July 22, 2016

ADDENDUM NO. 04

RANKIN TRAILS AMPHITHEATER AND BASEBALL PARK

Rankin County, Mississippi

SYNTHETIC TURF COLOR & LAYOUT

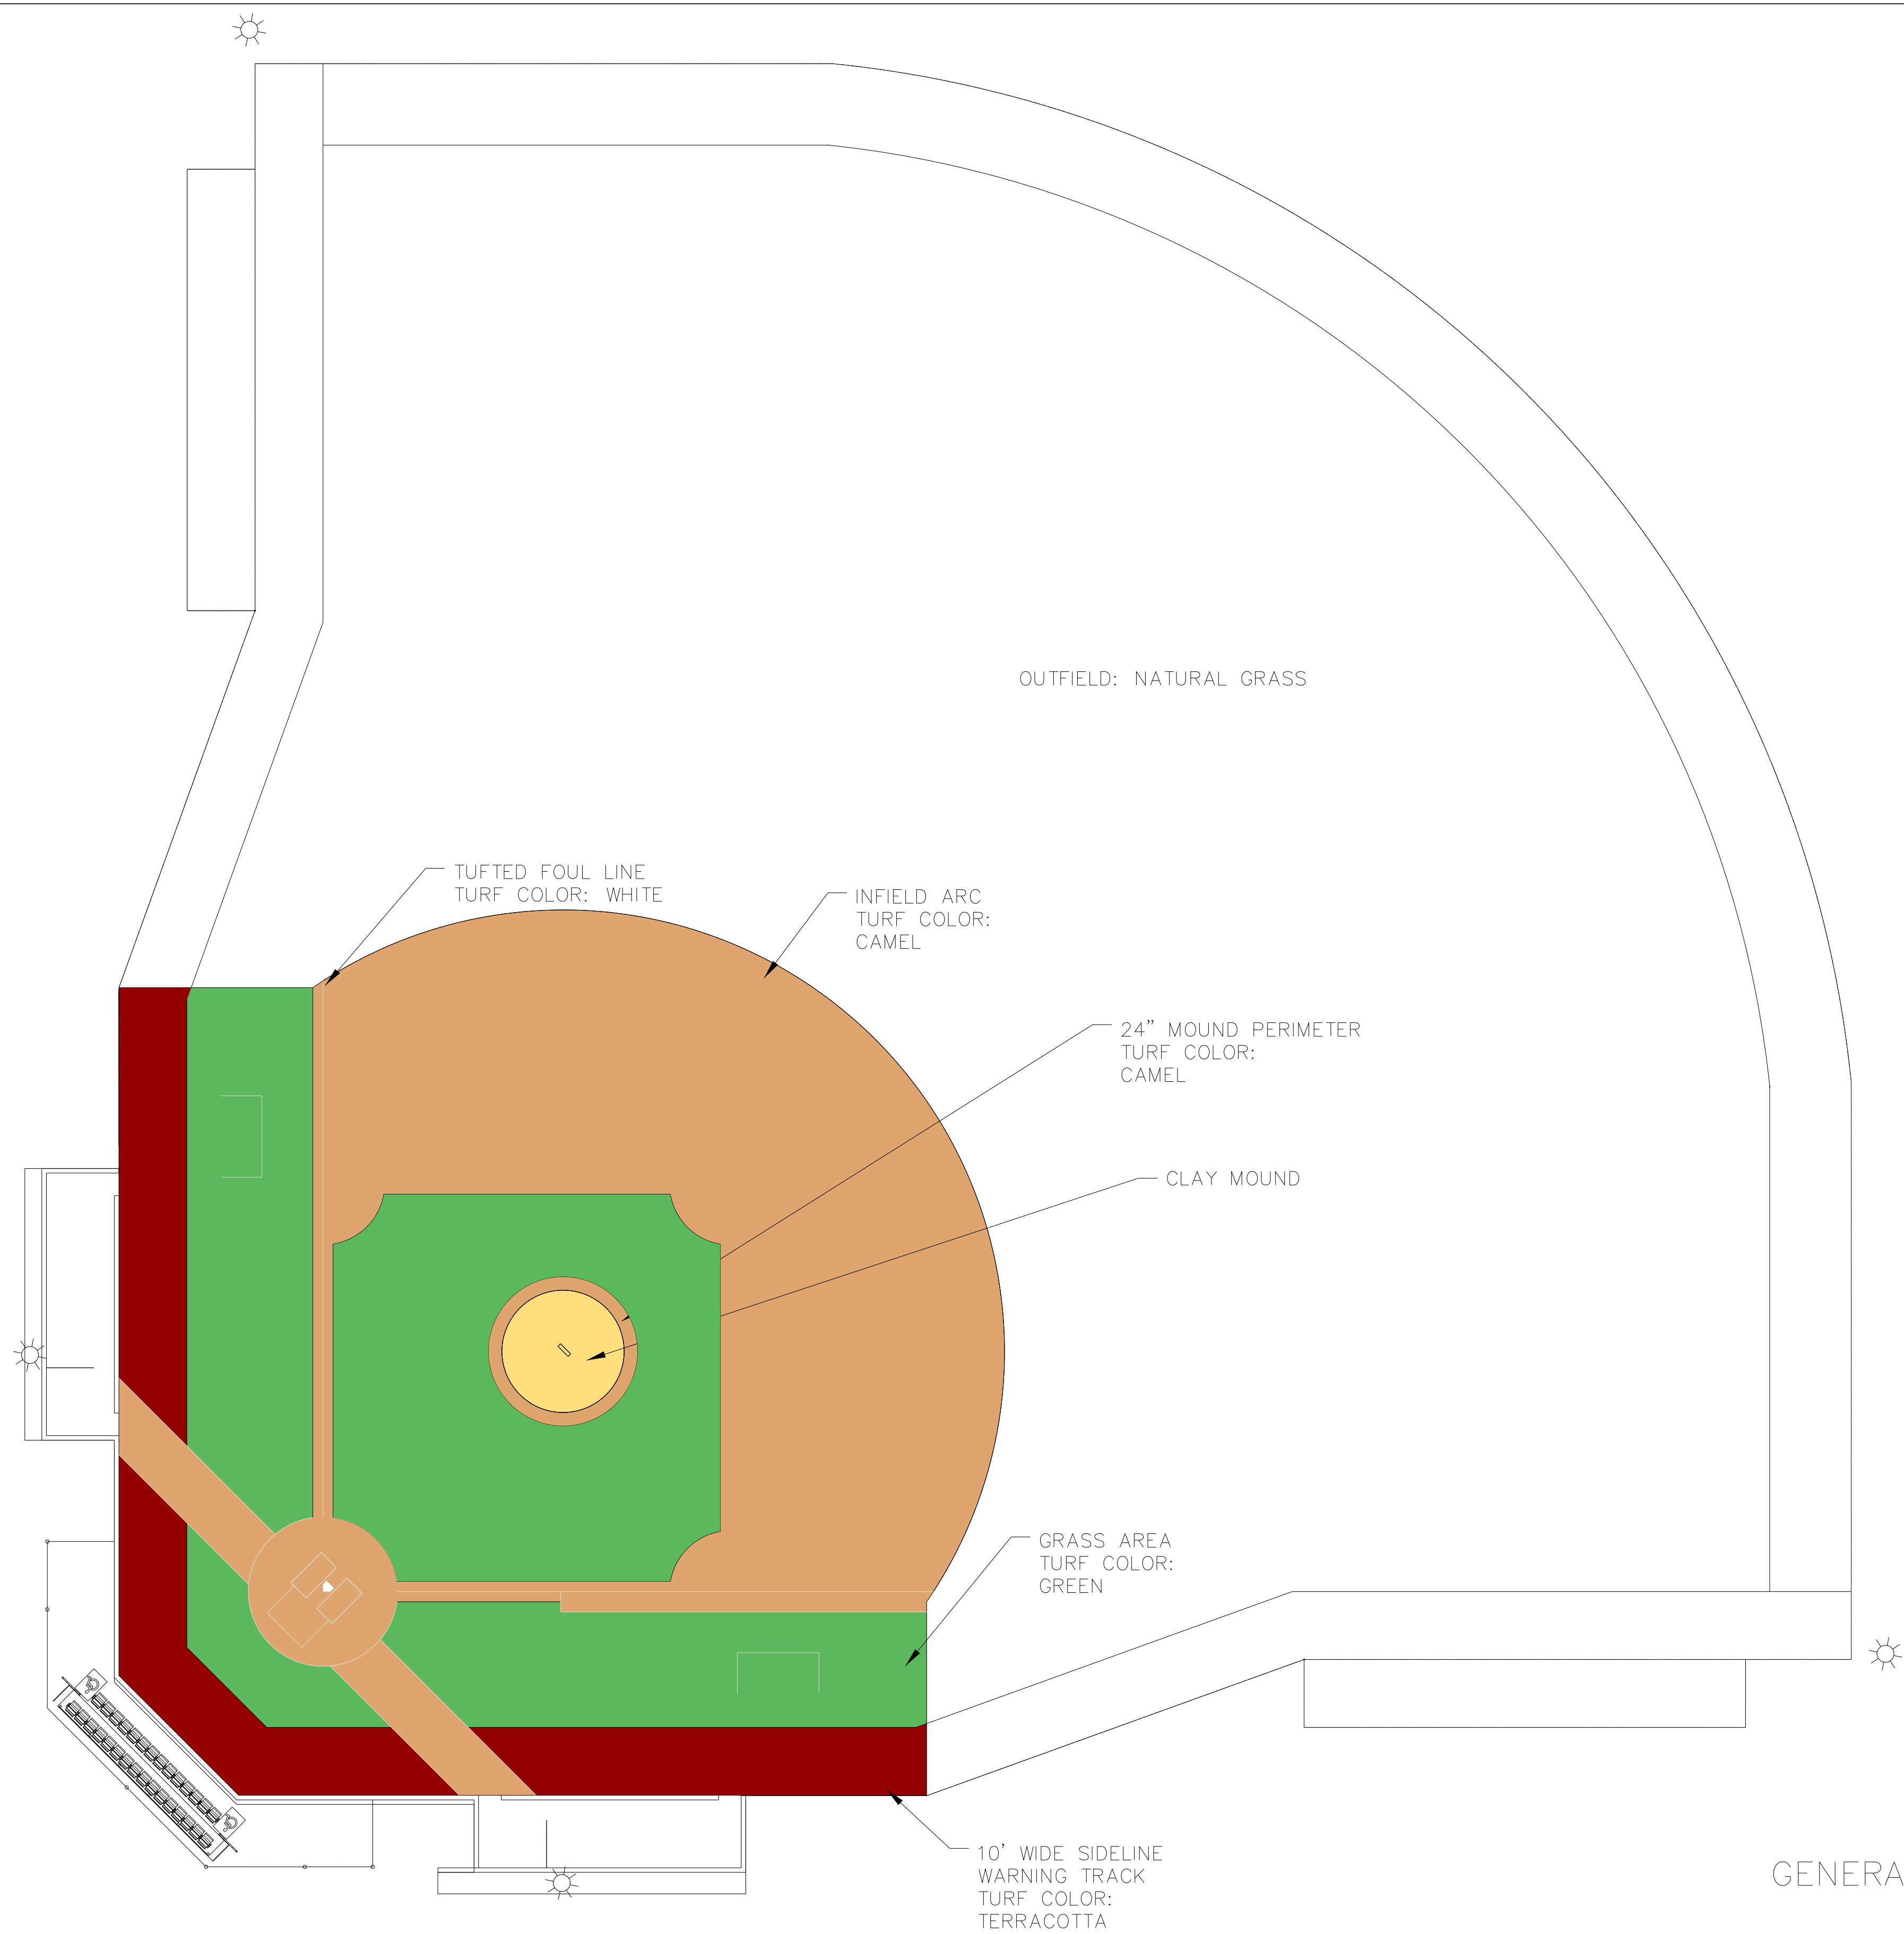
- ITEM NO. 30 SHEET C6.8**
REVISE per enclosed sheet C6.8. Revised legend on ballfield irrigation.
- ITEM NO. 31 SHEET C6.12**
REVISE per enclosed sheet C6.12. Clarified the limits of Color "Green" for synthetic turf. (PRINT IN COLOR).

1 FALL ARREST LAYOUT
S2.5
SCALE: 3/32"=1'-0"

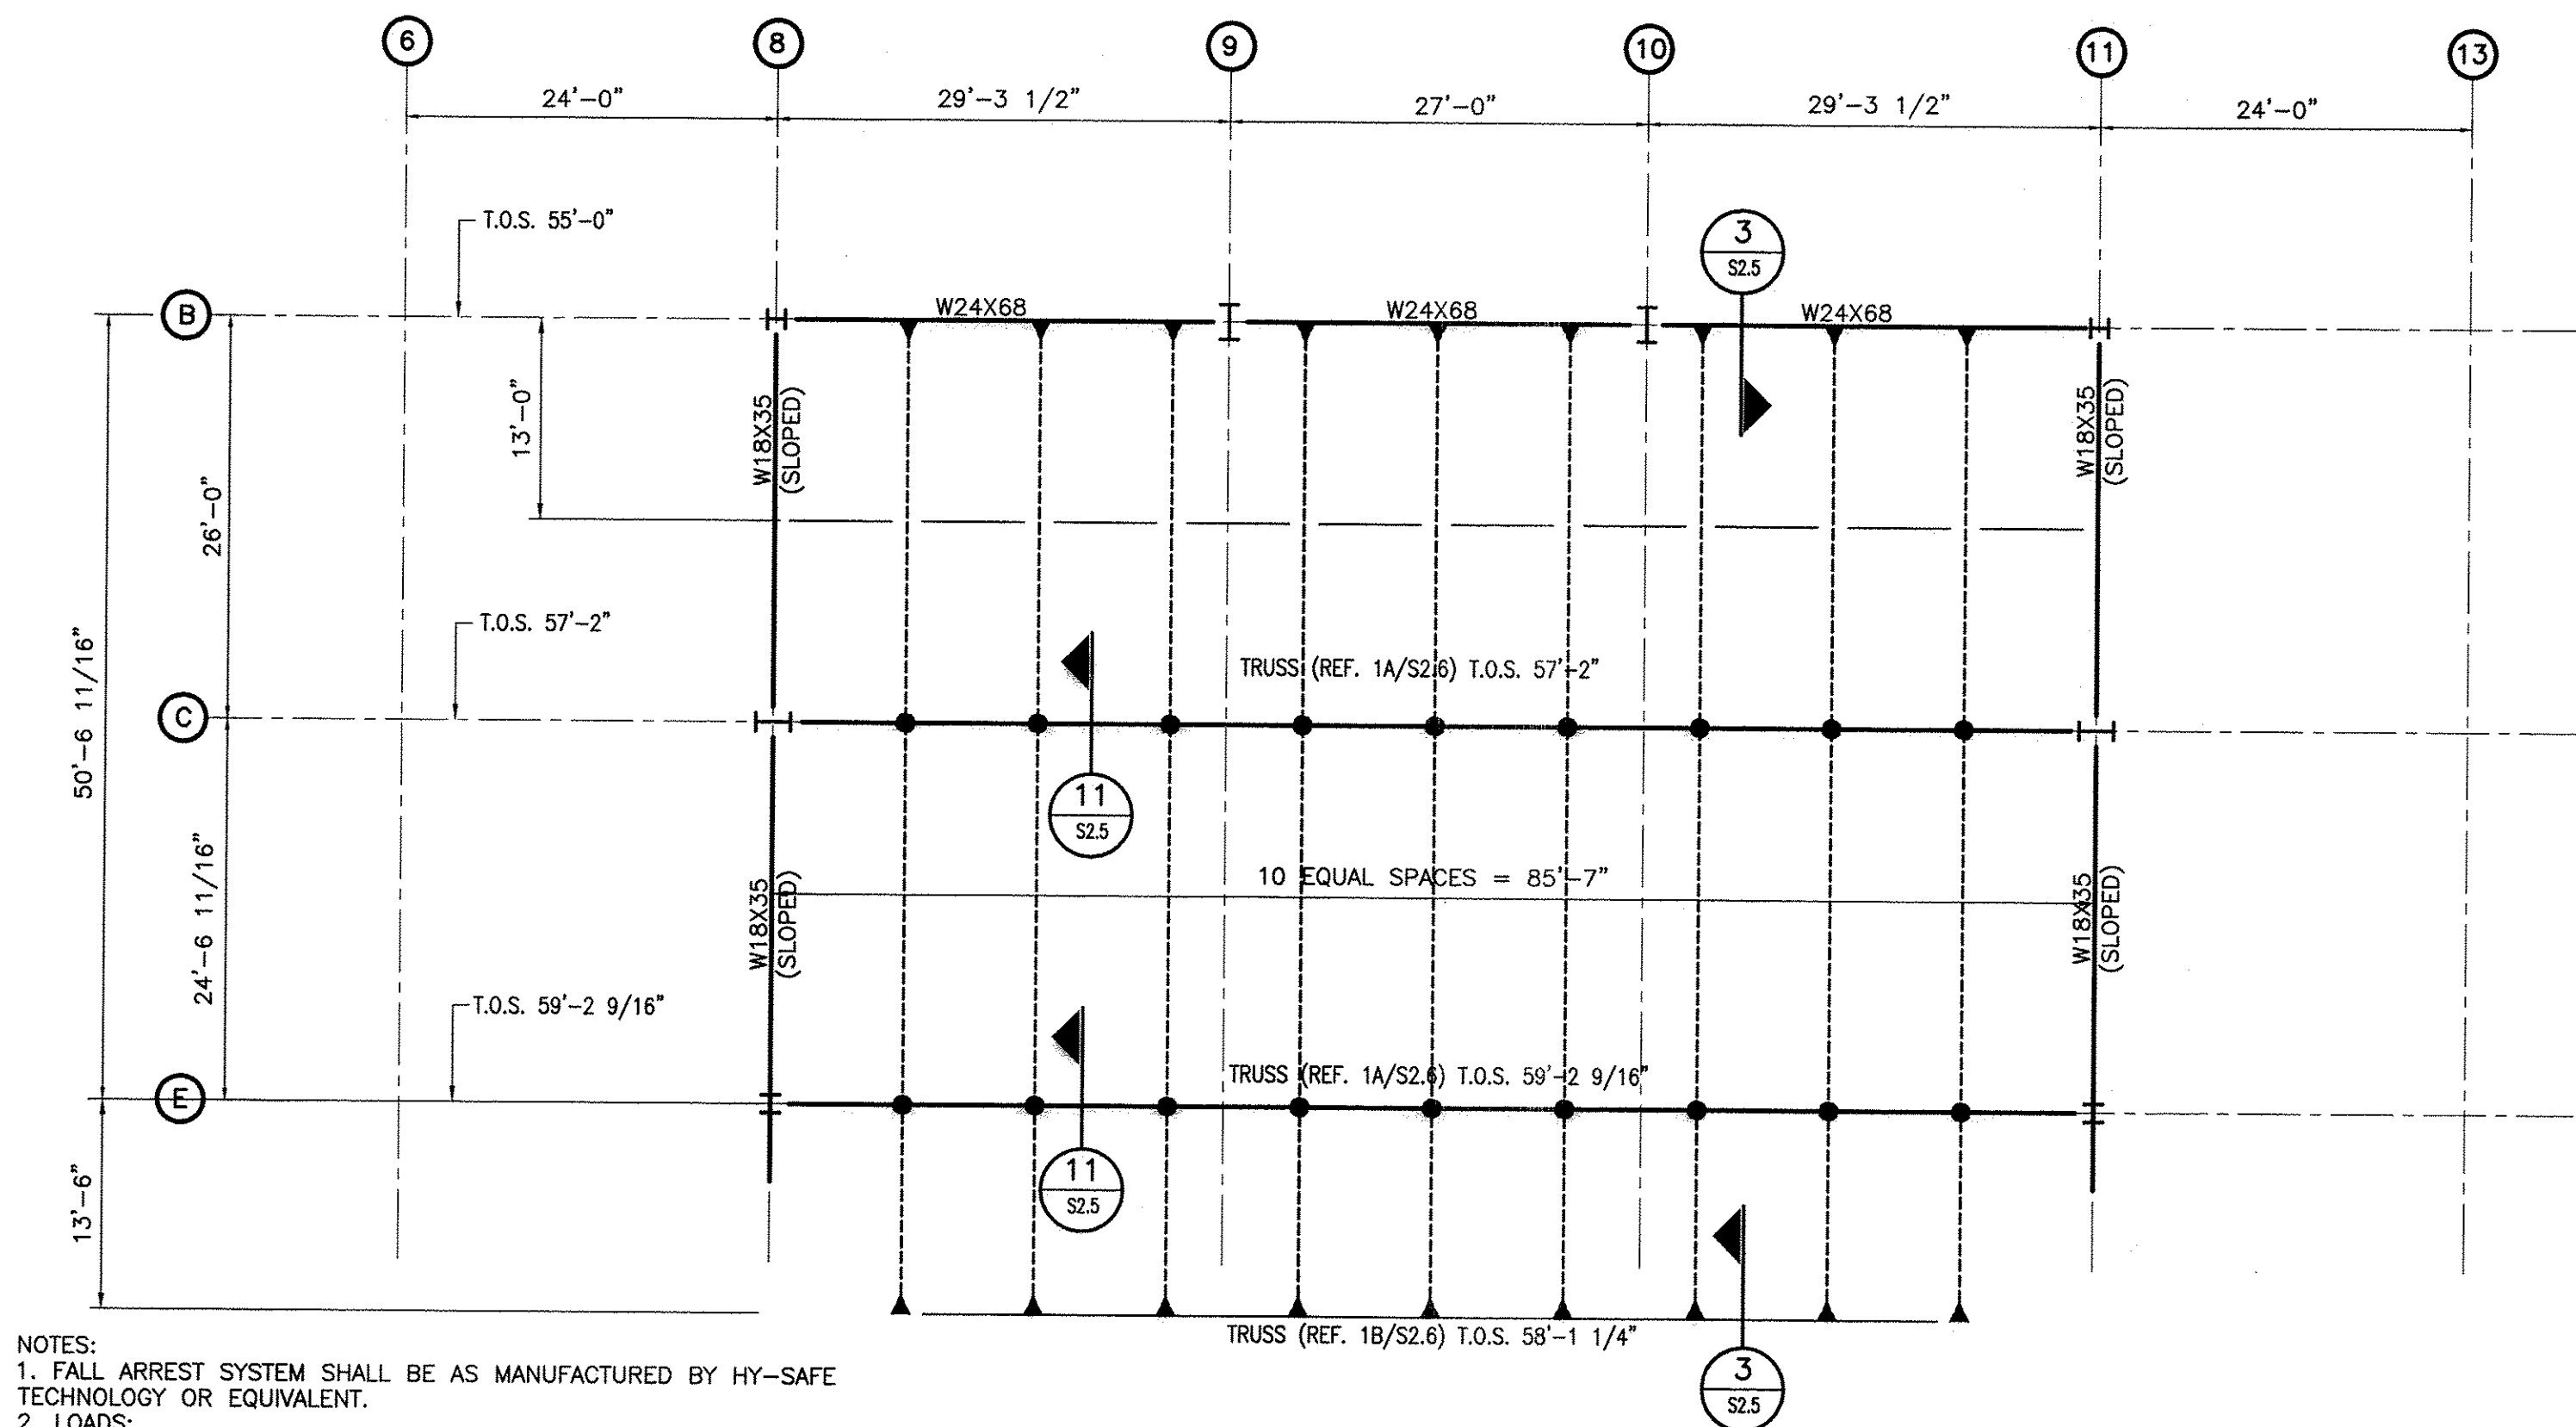
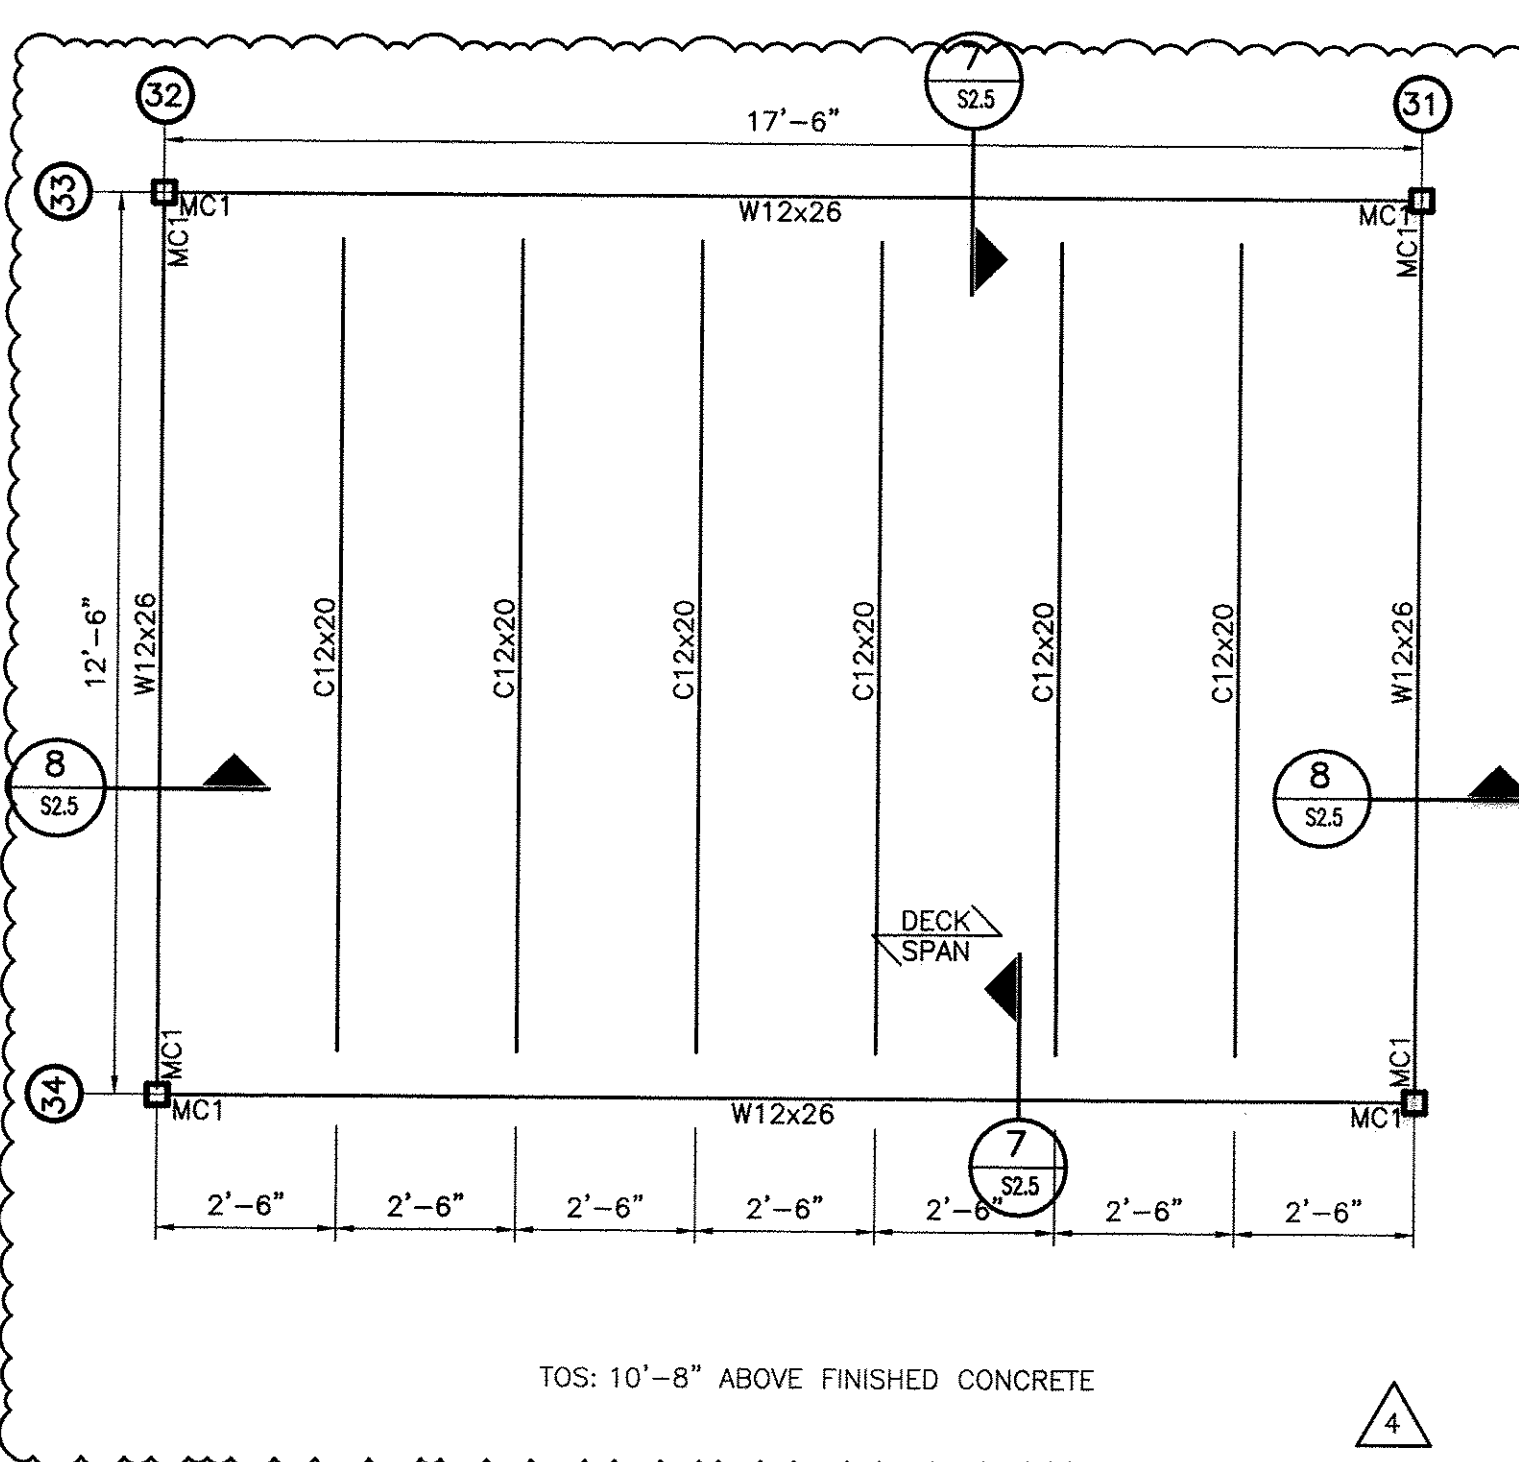
REMOVE: "2x10 pressure treated decking"
- ITEM NO. 36 SHEET S2.5**
CLARIFICATION: per enclosed sheet S2.5, column grids 31, 32, 33, and 34 have been labeled.
